A1 Birtley to Coal House

Applicant's Responses to ExA's Second Written Questions - Appendix 2.10B - Flood Modelling response to Environment Agency Comments

DATE:	28 January 2020	CONFIDENTIALITY:	Public
SUBJECT:	Flood Modelling Response to EA Comments		
PROJECT:	A1 BCH	AUTHOR:	Chris Parker
CHECKED:		APPROVED:	Andy Smith

Figure 1: URBEXT Map

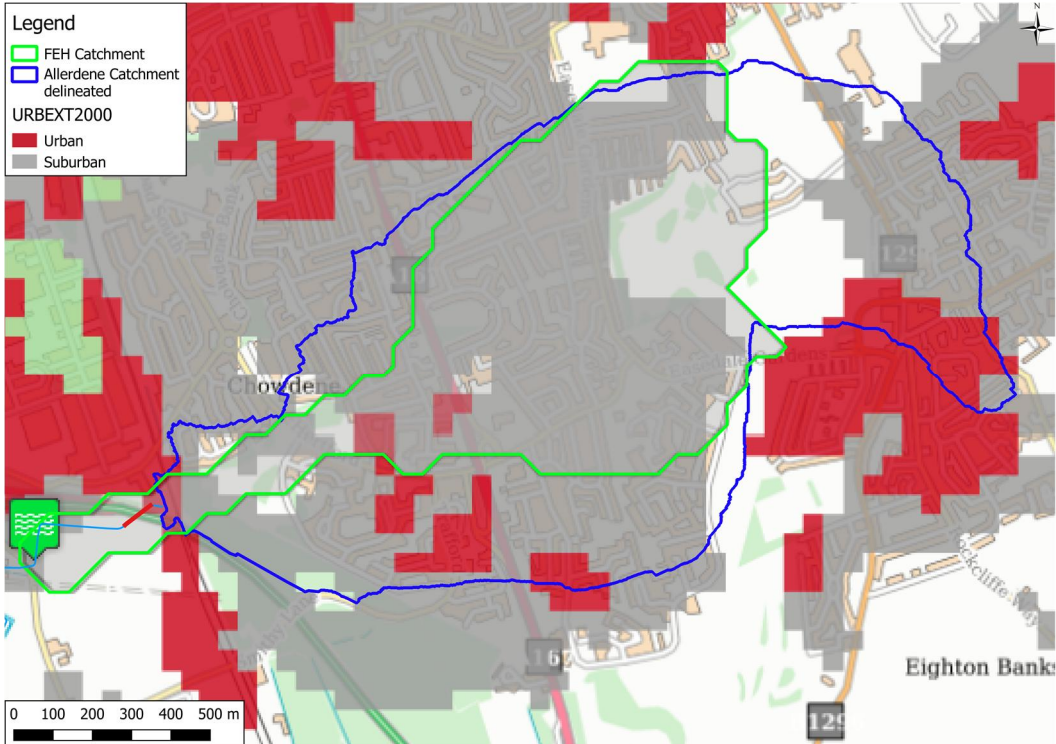
ID: A-6: NO FURTHER REPORTING GIVEN ON HOW THE CHANGE IN CATCHMENT AREA INFLUENCES OTHER KEY CATCHMENT DESCRIPTORS. DPLBAR SHOULD INCREASE, AND THERE COULD BE SIGNIFICANT CHANGES TO URBEXT2000 FROM THE CHANGE IN CATCHMENT BOUNDARY. BOTH OF THESE NEED TO BE ALTERED, AND COULD HAVE A BIG EFFECT ON CALCULATED FLOWS.

The catchment area has been delineated in GIS and has been compared to the URBEXT coverage, both of which are shown in Figure 1. The catchment descriptors have been updated in line with the identified change in catchment area, these are documented in Table 1

Figure 2 ReFH2 Growth Curves

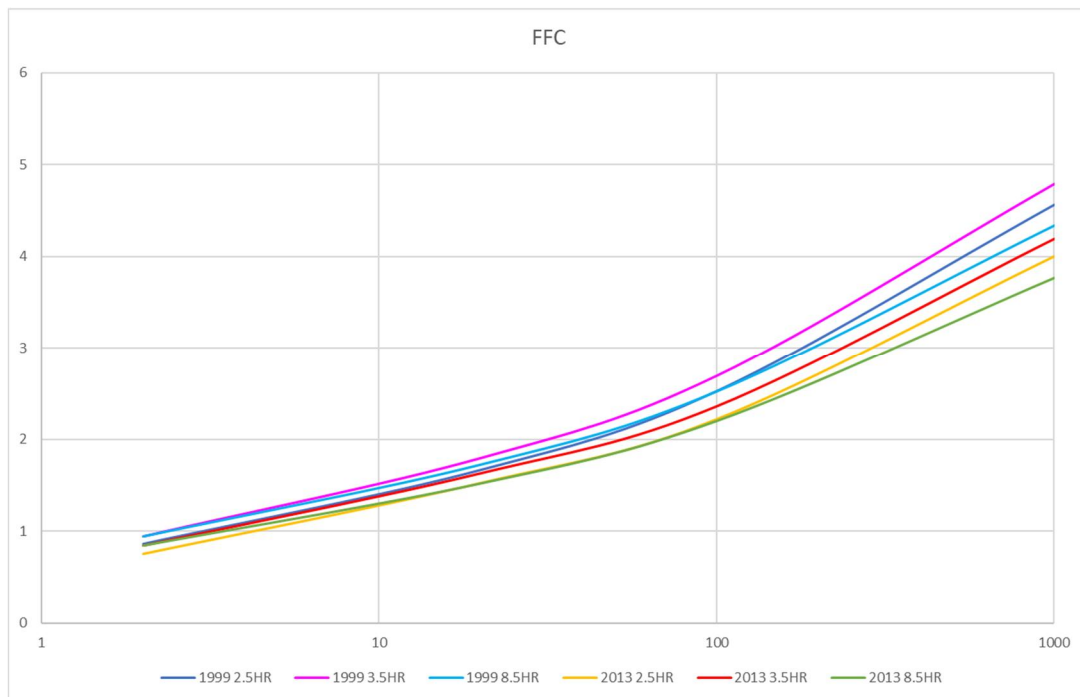
A-12: ADD A TABLE COMPARING FEH99 AND FEH13 RAINFALLS TO BACK UP THE ARGUMENT GIVEN IN CHAPTER 2 OF APPENDIX A. RUN THE REFH2 MODEL FOR THE 100 AND 1,000YR EVENTS WITH THE FEH13 RAINFALL ALSO, TO TEST IF THIS GIVES LARGER PEAK FLOWS, DUE TO THE "ALPHA" ISSUE.

The ReFH2 derived flows have been recalculated (within the ReFH2 software v2.2 and not within ICM) with the refined catchment descriptors as detailed in A-6, the revised flows are detailed in Table 2 and the growth curves in Figure 2, both are below, the key aspects / findings are:

Figure 3: J66 Flood Depths for the 1 in 100 year (1%) event

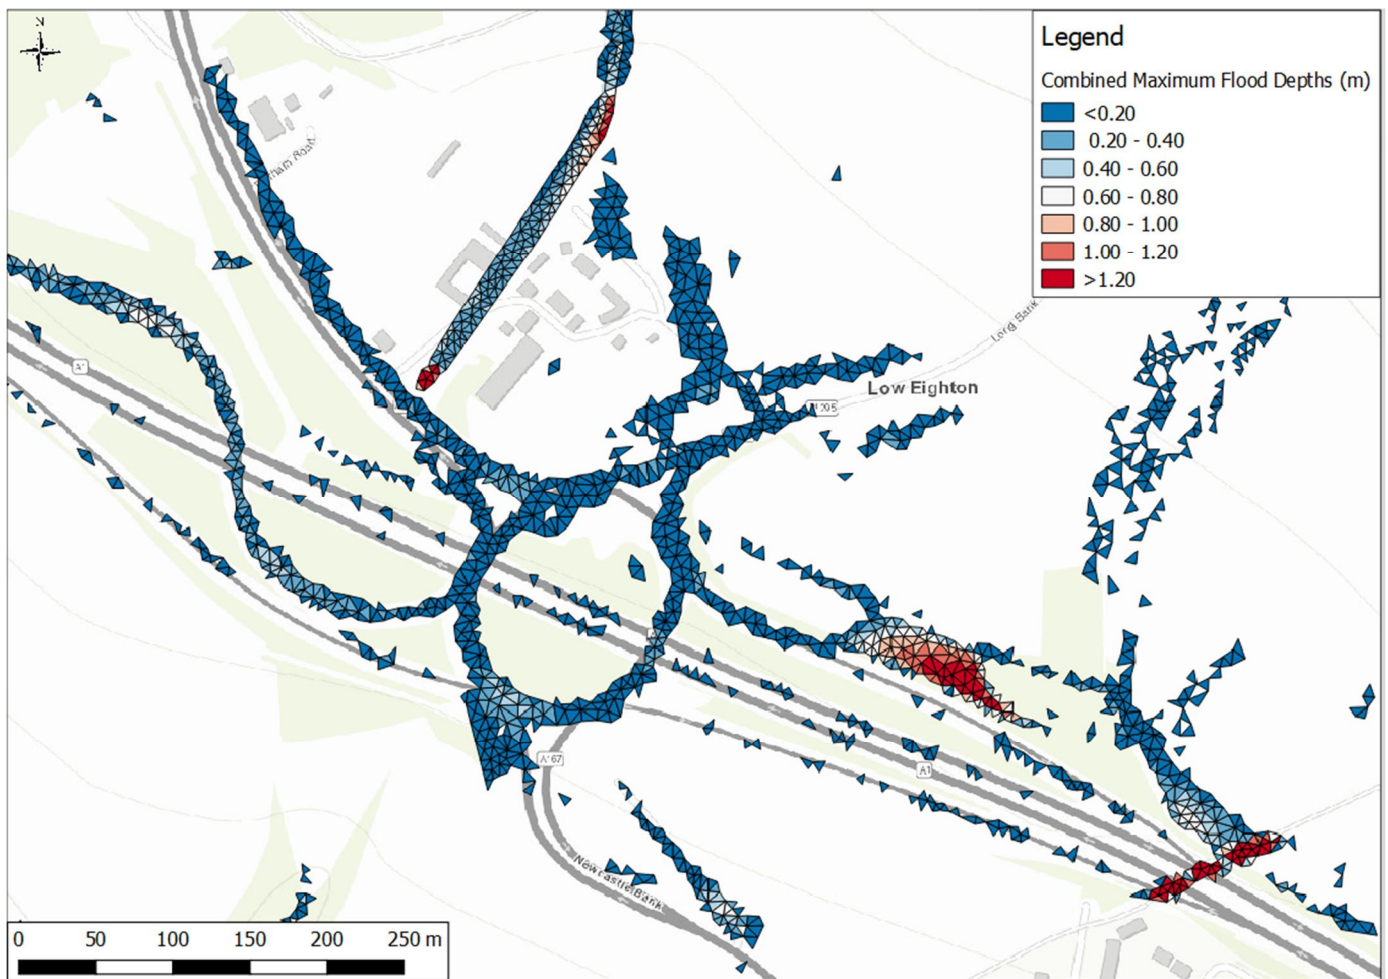
ID: A-32 THERE IS NO INFORMATION GIVEN ON THE RANGE OF STORM DURATIONS USED IN THIS DIRECT RAINFALL MODELLING IN THE REPORT.

the area of interest. However, as requested all the durations have been run and the results merged to obtain the greatest flood depths. The resultant 1 in 100 year flood map is shown on Figure 3.

Figure 4: Improvements to channel and left bank flows for the Kingsway Viaduct river reach (TEAM_5156.1) because of lowering the bank modular limits to 0.6 (option model)

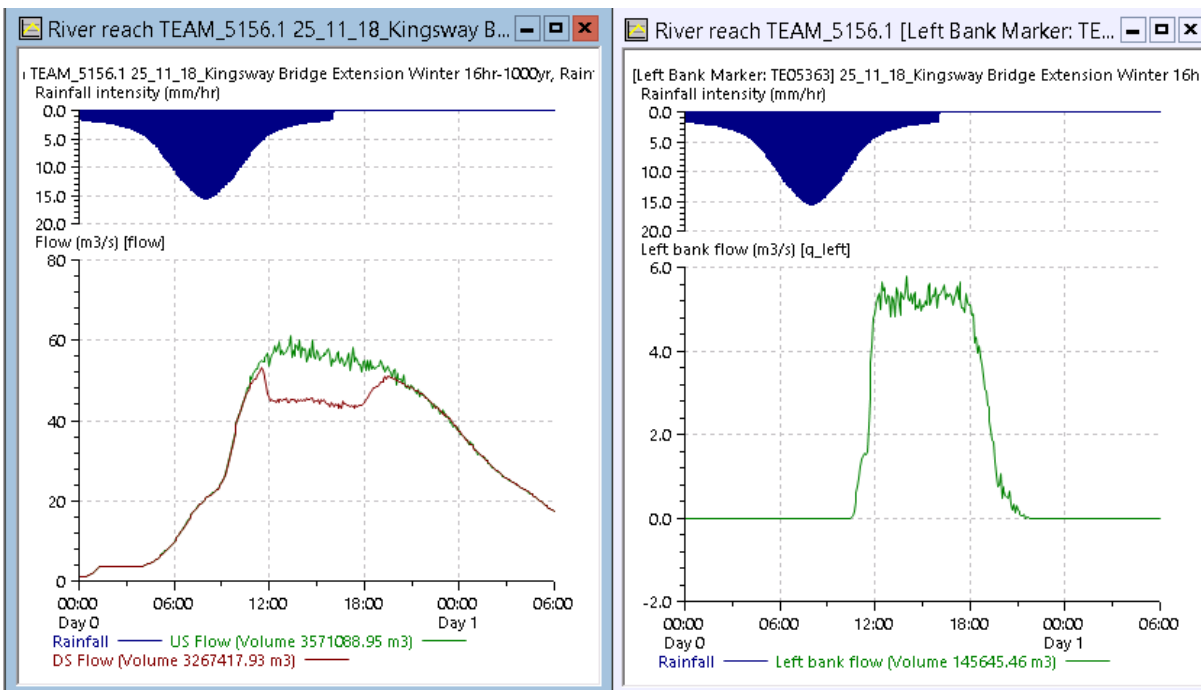
ID: B-29 MODEL STABILITY AND B-143 OUT OF BANK OSCILLATIONS

Lowering the bank line modular limit to 0.6 for the TEAM_5156.1 river reach improved left bank flow for the option model, as shown in Figure 4, but caused the original basemodel provided by the EA to fail. The change in modular limit had no impact on in channel flows. The stability problem seems to be a wider issue with the model for example, river reach TE05820.1 directly upstream of the Kingsway Viaduct, shown in Figure 5, shows significant oscillations to in channel and left bank flows. Resolving stability issues with the wider approved and provided Environment Agency model (as developed by JBA) is not required as part of

Figure 7: Existing model channel configuration

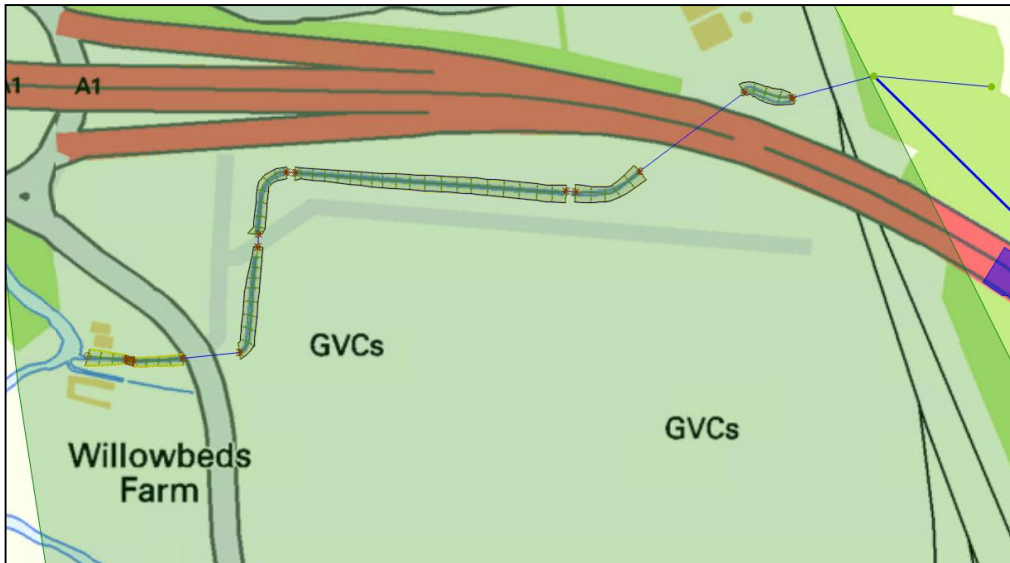
ID: B-8 SCENARIO CLARIFICATION

Figure 7 shows the baseline configuration / model schematisation.

Figure 11: Flow hydrographs at river reach ST02 DS.1 for 1 in 100 year flows with varying roughness

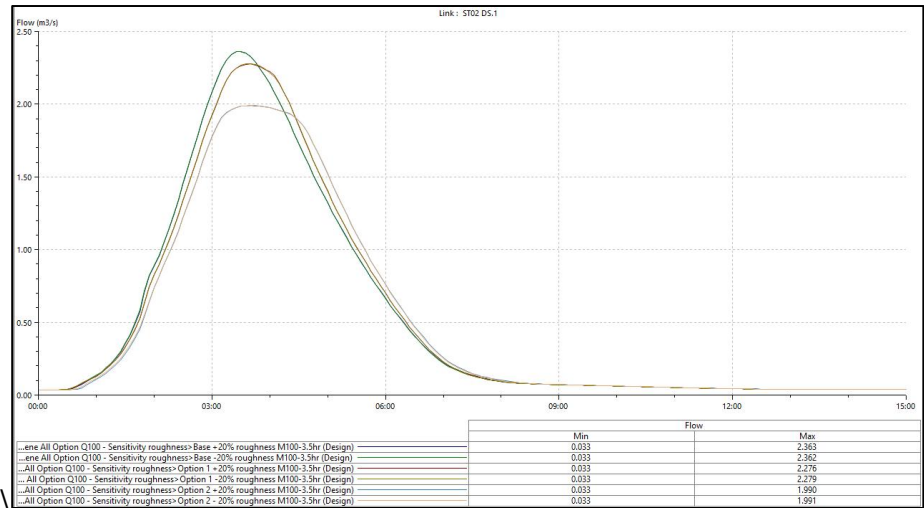
ID: B145 & B152 SENSITIVITY TESTING

Increasing channel roughness by $\pm 20\%$ has no impact on peak flows (Figure 10). However, for channel depths it does cause the maximum depth to vary by approximately 140-150mm (Figure 11) or approximate ± 70 -80mm compared with the baseline roughness values. This is considered to be within the acceptable model tolerance limits.

Figure 3: Left bank flows at TEAM_5156.1

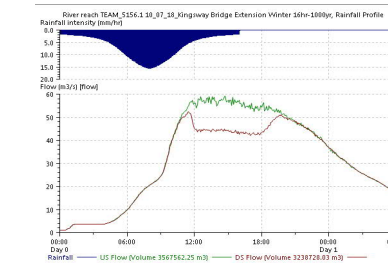
B-140	Total mass error = 9.9 m3	Acceptable		N/A
		B-141	Volume balance error = 0.9 %	Acceptable		N/A
		B-142	There is some oscillation in the peak flows in the area of interest during a 0.1% AEP event (Figure 2)	Minor issue	Make updates to conveyance and bank lines to improve stability	See response to B-29
		B-143	There is some significant oscillations in the out of bank flows in the area of interest during the 0.1% AEP event (figure 3)	Major issue	Make updates to conveyance and bank lines to improve stability. If appropriate, lower bank co-efficient	See response to B-29
	Sensitivity testing	- Suitability of sensitivity testing undertaken - Results & interpretation of sensitivity testing	B-144	Sensitivity tests not provided for review	Minor issue	Run sensitivity tests
Calibration / performance		B-145	No model performance testing was provided for review.	Minor issue	Use the model report to provide commentary on the sensibility of predicted flooding.	This is addressed within the accompanying technical note

Figure 2: Kinked conveyance at higher depths

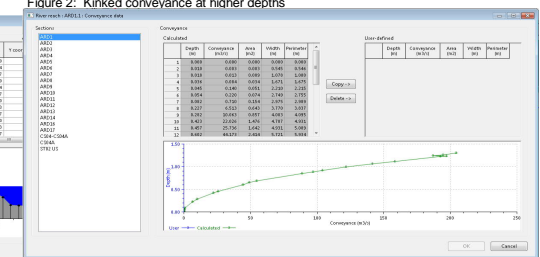
Mesh modifications	- Representation of roads and buildings - Roughness	B-41	1D-2D linking happens at bank lines which has been successfully achieved.	Acceptable		N/A	
		B-42	There is no representation of the conveyance in highways or the resistance caused by buildings.	Minor issue	Represent buildings, road, woodland, scrub as roughness zones in the 2D model.	This model covers a small area and this level of detail is not required in this instance	
InfoWorks ICM		B-43	However, the raised highway embankment are represented in the DTM and therefore the mesh.	Acceptable		N/A	
		B-44	Option 1a: Ditch re-alignment A Mesh Level Zone has been added over the existing watercourse. This adjusts the DTM elevation to give a minimum elevation of 16 mAOD and maximum elevation of 17.5 mAOD. A 3D view indicates that this level zone has lowered the existing embankment. There has been no modification of the ground levels to tie in with the proposed bank heights. In some locations this can cause a 1m discrepancy between 1D and 2D bank level. This is not shown to impact 0.1% AEP results. The extended culvert has been connected to the proposed culvert with a break node. I would think it more likely that a manhole chamber would be installed to connect these. A manhole would have the potential to flood whereas a break node does not. However, the pipe is not surcharged at the peak of the 0.1% AEP event so this is not thought to impact results. The roughness of the proposed culvert has not been updated from default. The new cross sections mainly look sensible but ARD1 - ARD4 all have left bank lower than the highest point, allowing for premature flooding (Figure 1). However, the max water level doesn't exceed left bank level in the 0.1% AEP event so this is not thought to impact results. The conveyance of the new cross sections is kinked at higher depths (Figure 2). However, the max water depth doesn't reach this level in the 0.1% AEP event so this is not thought to impact results.	Acceptable - but does not meet best practice		N/A

Figure 3: Bank level miss match

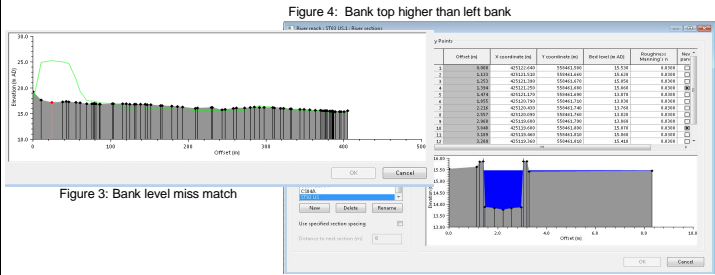
Calibration / performance		B-153	No model performance testing was provided for review.	Minor issue	Use the model report to provide commentary on the sensibility of predicted flooding.	This is addressed within the accompanying technical note
